PACKARD

# Service Counselor

AUGUST 15, 1947

## Correction of Reverse Gear Lock-Up On Clippers Equipped with Overdrive

Figure 3B—Overdrive Solenoid Engaged

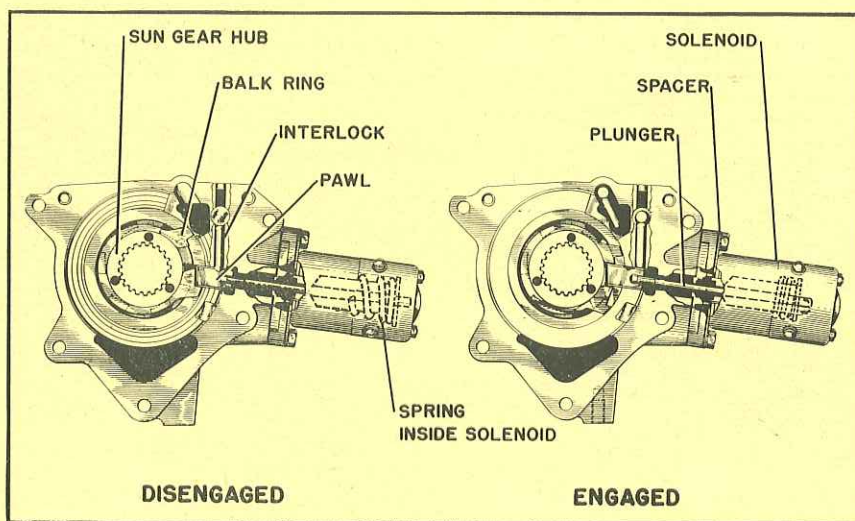
When a non-standard condition exists in the overdrive electrical system whereby the solenoid remains energized when the car has been brought to a stop, engine power will be transmitted through the planetary gear train with the following results.

On the other hand, if the transmission is shifted into reverse gear and engine power applied, the overdrive unit will become locked in the following manner. The sliding pawl holds the interlock plunger up into its detent in the shifter rail. (See figure 3B.) This prevents the shifter rail from moving and the clutch sleeve in turn cannot engage the free wheel cam and the tail shaft and lock the two into a single unit. Engine power is transmitted from the transmission driving shaft, through the sun gear and planetary gear train, the clutch sleeve, and then to the tail shaft. Since the planetary gear train increases the speed of the tail shaft, the tail shaft rotates faster than the free wheel cam and causes the rollers to lock the cam

and the tail shaft into a single unit. But, since the free wheel cam is splined to the transmission driving shaft, the cam and the tail shaft cannot rotate faster than the transmission driving shaft and the overdrive becomes locked.

Figure 4—Schematic Wiring Diagram of Overdrive Circuits

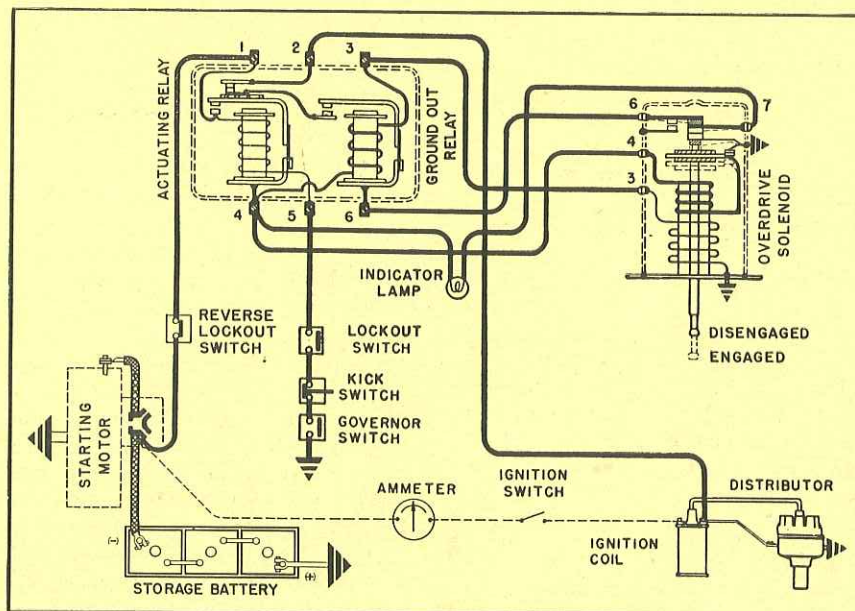
As previously stated, this reverse lock-up usually is the result of a non-standard condition in the overdrive electrical system and it is suggested that the electrical system first be checked since the trouble may be attributed to any one or combination of the following:

1. Governor assembly contact points closed or sticking.
2. Lockout switch grounded.
3. Kick-down switch grounded.
4. Kick-down switch relay contact points closed or sticking.
5. Electrical wiring shorted to ground.

As you will note in the schematic wiring diagram (See figure 4.) the governor switch, kick-down switch, and the lockout switch are connected in series and are located between the relay and ground. Therefore, it is possible for the solenoid to remain energized due to any one of the five reasons listed.

Disconnect cable from the No. 1 terminal of overdrive relay. (See figure 4.) Cut cable off flush with braid on body wiring harness.

Figure 5—Schematic Drawing of New Overdrive, Reverse Lockout and Backing Light Equipment  
Switch Shown Out of Position To Show Location of Terminals

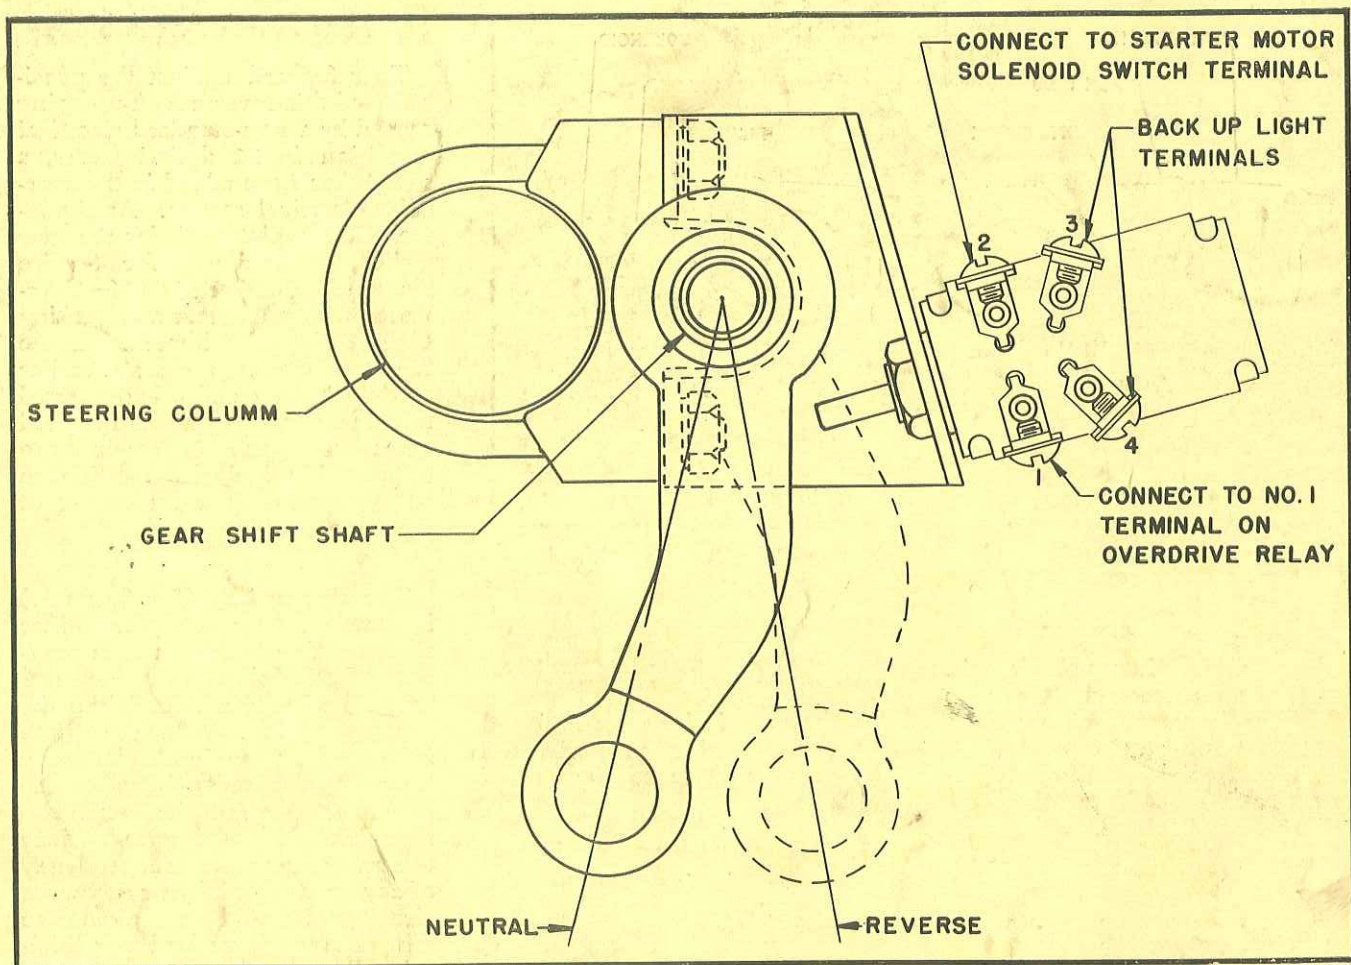
To safeguard against the possibility of this reverse lock-up being caused by a non-standard electrical condition in 22nd Series cars, a switch has been added in the overdrive electrical system. An Equipment Kit, which includes the new switch, is available for Service under part number 394484—Overdrive Reverse Lockout and Backing Light Switch Equipment. These kits may be used on all earlier model Clippers and it is suggested that one of these kits be installed whenever a car is serviced to correct this locked condition in order to prevent a recurrence of the same trouble.

The new switch (See figure 5.) is attached over the gear shifter shaft housing bracket and is operated by the first and reverse lever when the lever is shifted into the reverse position. When the switch is opened by the first and reverse lever, the circuit between the battery and the relay is broken and the solenoid is de-energized. Since this switch functions independently of any other unit in the system, the circuit still would be broken even though a non-standard condition existed anywhere between the relay and ground.

Run the cable along the body wiring harness to starter motor by means of clips and then across to the safety switch. Connect the cable to the No. 1 terminal. (See figure 5.)

Connect the short wire with the fuse container plug furnished in the kit to the No. 2 terminal on the safety switch. (See figure 5.)

The two rear terminals (No. 3 and No. 4, figure 5) are used only when backing light equipment is installed. The switch included in the Backing Light Kit may be discarded when a backing light is installed on a car having the new overdrive safety switch.
